UNITED STATES PATENT AND TRADEMARK OFFICE

APPLICATION NO.	FILING DATE	FIRST NAMED INVENTOR	ATTORNEY DOCKET NO.	CONFIRMATION NO.
10/718,530	11/24/2003	Helmut Schwartz	P24417	1995
7055	7590	03/02/2006	EXAMINER	
GREENBLUM & BERNSTEIN, P.L.C. 1950 ROLAND CLARKE PLACE RESTON, VA 20191			MITCHELL, KATHERINE W	
			ART UNIT	PAPER NUMBER
			3677

Office Action Summary

DETAILED ACTION

Fig.1**Fig.3**

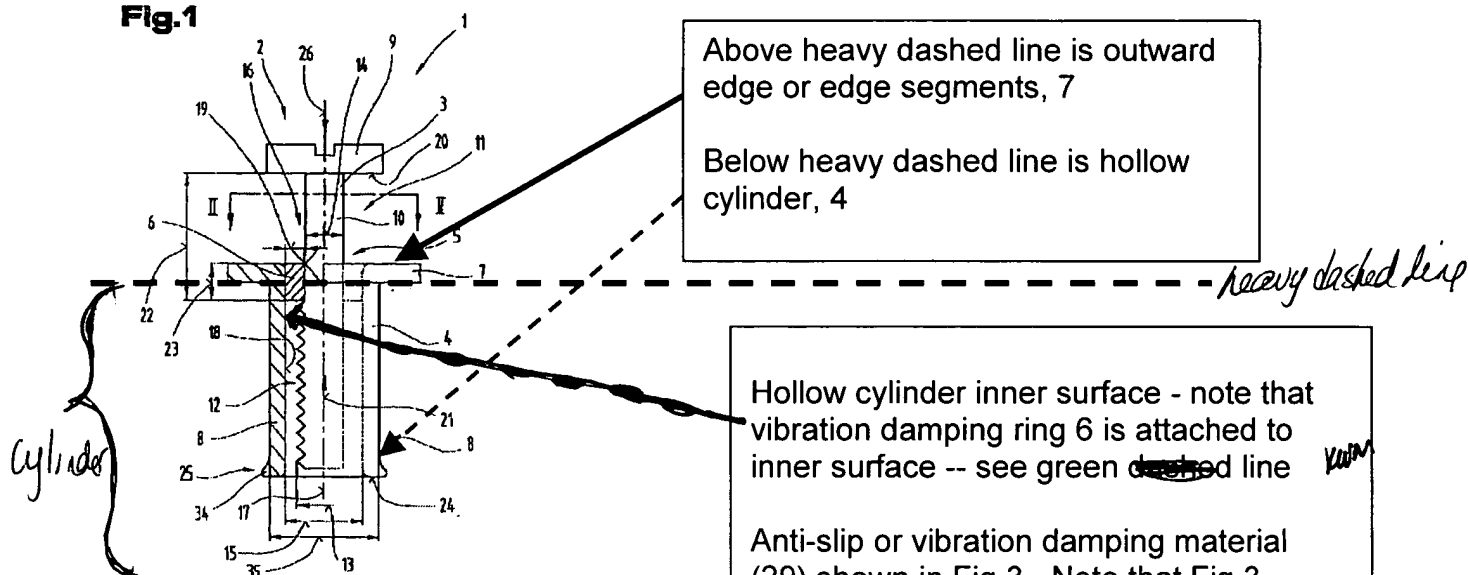
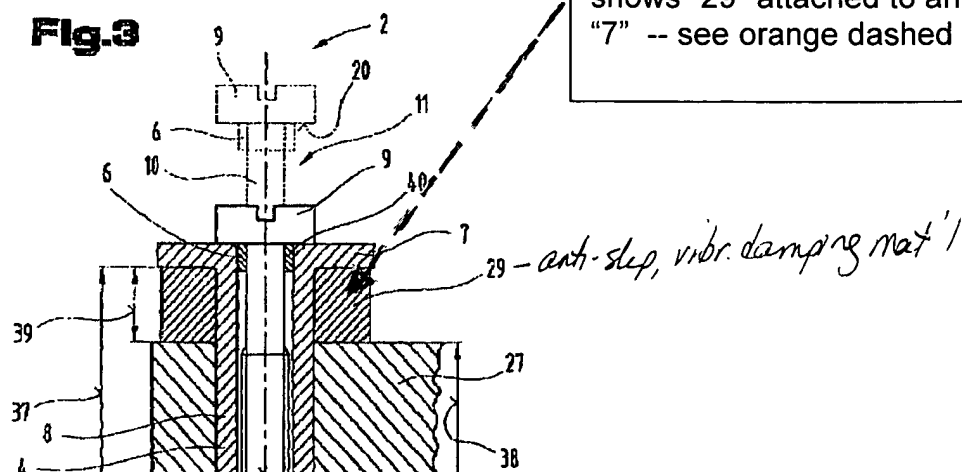
Re claim 1: Radtke teaches a vibration damping ring inert arrangement comprising: A vibration damping ring(6). Note that while examiner refers to embodiment Fig 1-3, ring (6) is the same in both embodiments as described in para. [0029, 0040].

- A hollow cylinder (4) with 1st and 2nd ends and an inner surface connected to the outer surface of the ring
- An outwardly extending edge 7 arranged at the 2nd end (flange-like projection 7 in Fig 1 and 3.)
- Anti-slip or vibration damping material (29) attached to an annular surface of the edge or edge segments, either of which are outwardly extending.

Re claim 9: The outwardly extending edge is substantially perpendicular to an axis (17) running through the cylinder.

Re claim 37: Part 27 and part 28 are coupled via the vibration damping insert arrangement per Fig 3 and paras [0031] and [0037]. Note that “through-opening” was not claimed.

Applicant state that RADTKE fails to disclose that the outwardly extending edge and edge segments are not substantially perpendicular to the hollow cylinder -- Figs 1,3, and 4 clearly show the outward edge 7 substantially perpendicular to axis 17, 31.

Note that now Radtke's vibration damping ring is 6 and material is 29.

FIG. 2

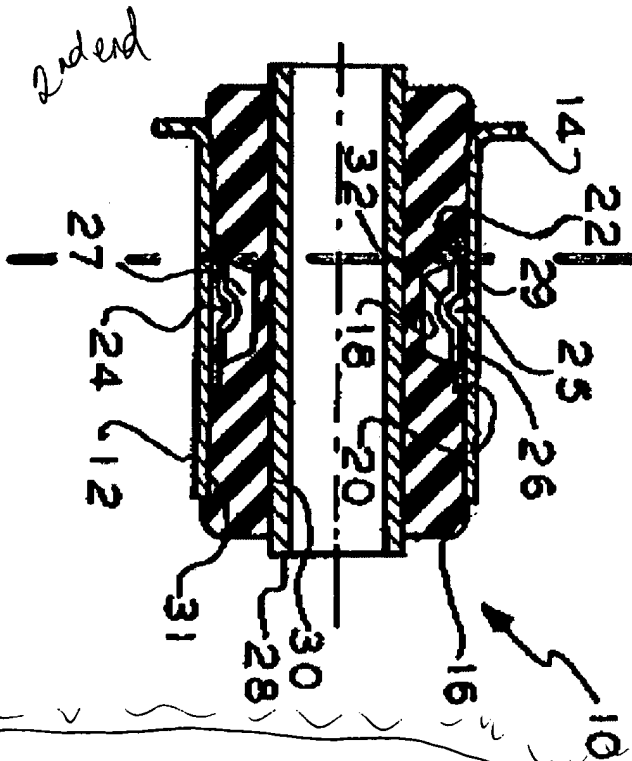
- A vibration dampening ring (16, lower part at and below encircling ring 22 as oriented in Fig 2 below)), col 3 line 64-col 4 line 40.
- A hollow cylinder (12) with 1st and 2nd ends and an inner surface connected to the outer surface of the ring (16, lower part)
- An outwardly extending edge arranged at the 2nd end (14, Fig 2.)
- Anti-slip or vibration damping material (16, upper part above encircling ring 22 as oriented in Fig 2 below) attached to an annular surface of the edge or edge segments, either of which are outwardly extending. Also, note that “ring” and “material” are not equivalent terms, and thus the vibration damping ring can be considered to be the entire unit “16”, made in its entirety of the anti-vibration or anti-slip material – the “ring” element can also be the “material” composition.

Interpretation 1:

anti-slip or vibration damping material
is above blue lens

— blue dashed line

vibration damping ring, below
blue dashed line.

FIG. 2

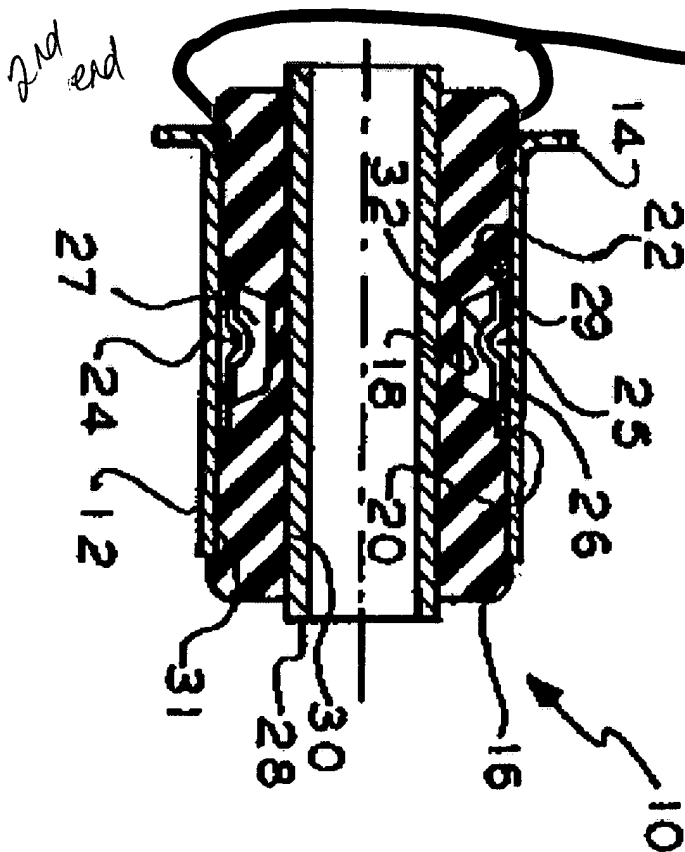
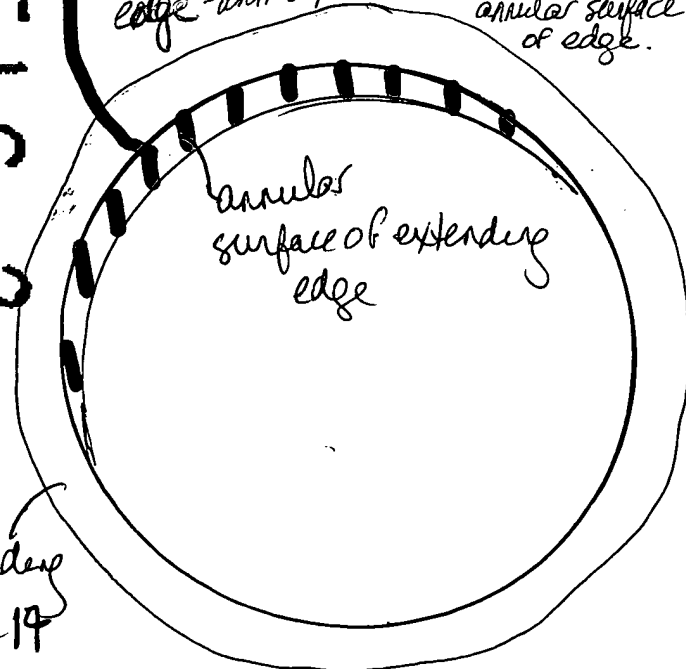
Interpretation 2:

entire elastomeric cylinder 16 is
vibration damping ring, made of
anti-slip, vibration damping material

Red vertical line - represents
annular surface of extending
edge - anti-slip material attached to
annular surface
of edge.

extending
edge 14

Re claim 9: The outwardly extending edge is substantially perpendicular to an axis (Fig 2) running through the cylinder.

Re claims 10-12 and 47: Fig 2 shows the vibration-dampening ring having 1st and 2nd annular projection portions extending beyond the respective ends of the hollow member by an equal given amount. Note that in this situation, the vibration damping ring is considered the entire element "16", and the anti-slip and vibration-damping material is the material that the ring is made from.

Re claim 13: Fig 2 shows the 2nd end as an annular base surface.

Regarding Roth claim 1, applicant has amended the claim, so certain features were not previously noted by examiner. See the marked-up Figure for both ways to interpret Roth teaching a cylinder with anti-slip and vibration damping material attached to annular surface of outwardly extending edge. Applicant is now arguing "attached to the flange" (page 19), but the claim does not require attachment to the flange.
